IDLE CURRENT MODIFICATIONS

STUDIO PRO®

BJ.# 98002131
98002131

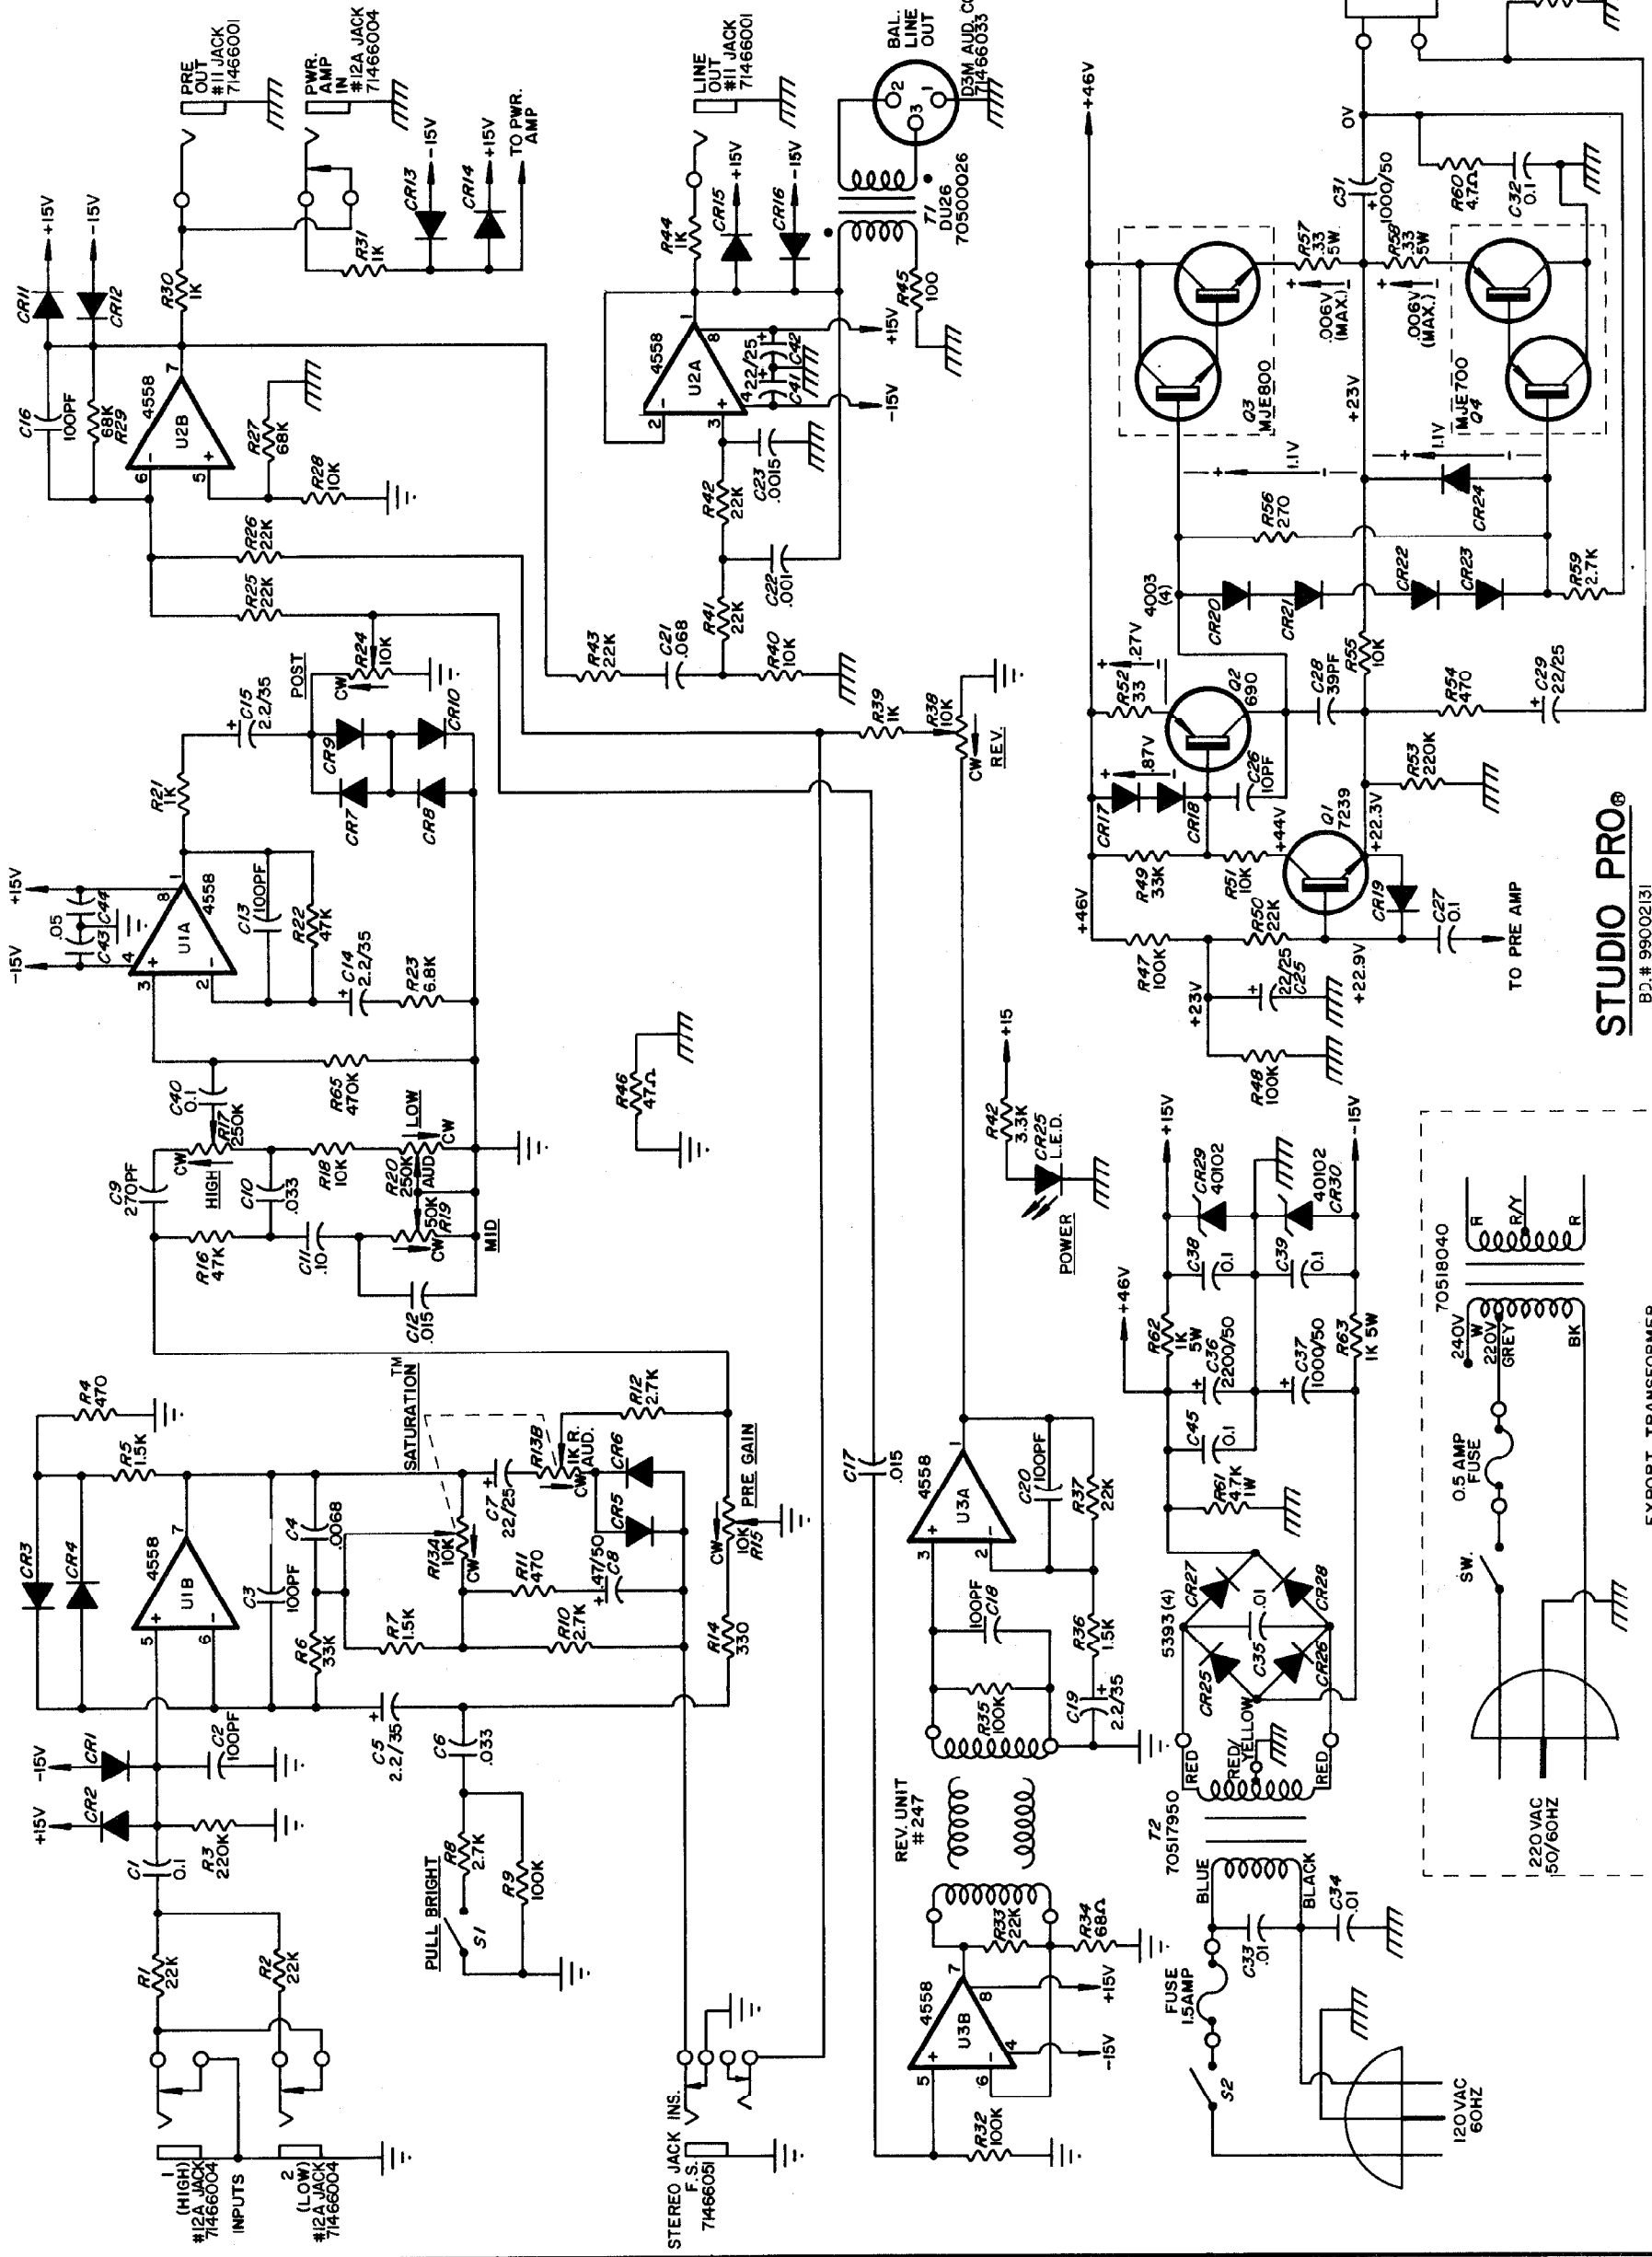
- 1) REPLACE R53 (220K) WITH A 100K 1/4 WATT
 - 2) MAKE SURE R56 IS A 330 ohm
 - 3) ALLOW UNIT TO OPERATE INTO LOAD AT APPROX. 1/2 POWER FOR ABOUT 1 MINUTE
 - 4) REMOVE SIGNAL AND READ THE VOLTAGE ACROSS R57
 - 5) IF THIS VOLTAGE IS ABOVE .006VDC THEN BRIDGE R56 WITH A 2.7K 1/4 WATT
 - 6) IF THE VOLTAGE IS STILL ABOVE .006VDC THEN REMOVE THE 2.7K AND TRY A 1.5K 1/2 WATT
- NOTE: HIGH IDLE CURRENT MAY BE THE RESULT OF SOME LEAKY COMPONENT ELSEWHERE IN THE POWER AMP. THIS SHOULD BE TAKEN INTO CONSIDERATION BEFORE MODIFYING
